DART AEROSPACE LTD		Work Order: 147567
Description: Crosstube High Fwd, SS (AS350/355)		Part Number: D350-748-103
Inspection Dwg: D350-748-143 Rev: A		Page 1 of 1

DRAWING NO. D350-748-143
REV. A
SHEET 1 OF 4

TITLE CROSSTUBE (AS 350/355 HI FWD)
SCALE NTS

DRAWING NO. D350-748-143	TITLE CROSSTUBE	REV. A	DART AEROSPACE LTD ENGINEERING ORDER		D.E.O. NO. D350-748-143-A-1	SHEET NO. SHEET 1 OF 1	SCALE NTS
DRAWN <i>q</i>	CHECKED <i>ASS</i>	MFG. APPR. <i>J.M.</i>	APPROVED <i>[Signature]</i>		DE APPR. <i>[Signature]</i>		
DATE 15.11.18	DATE 15.11.18	DATE 16.02.19	DATE FEB 19 2016		DATE 2016.02.19

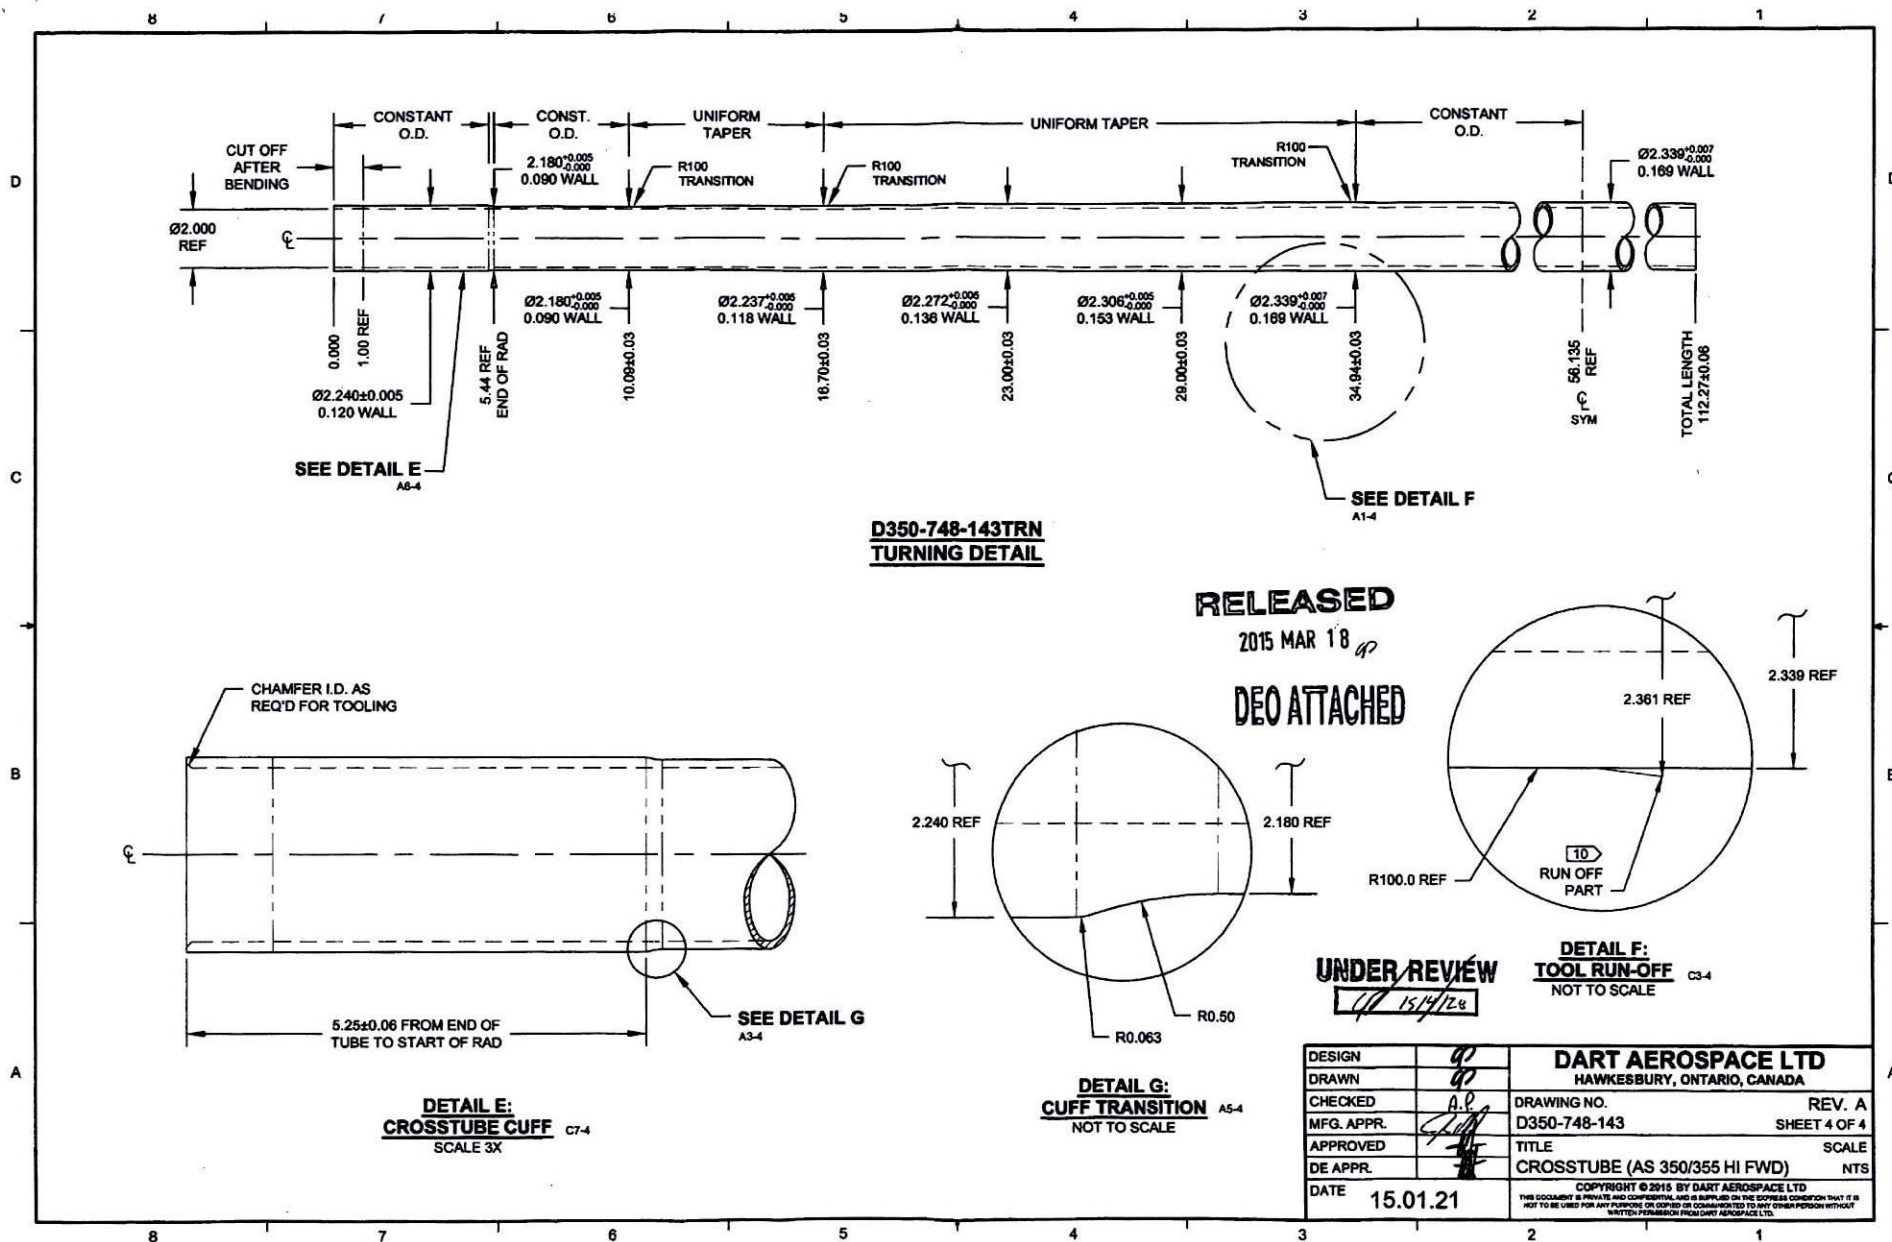
AMEND NOTE 2 (SHEET 1) AS FOLLOWS:

- 2) FINISH: PREPARE SURFACE PER DART QSI 005 4.1.4
 PRIME INSIDE AND OUTSIDE PER DART QSI 005 4.2
 PAINT OUTSIDE PER DART QSI 005 4.2
 OR
 POWDER COAT WHITE (4.3.5.2) PER DART QSI 005 4.3
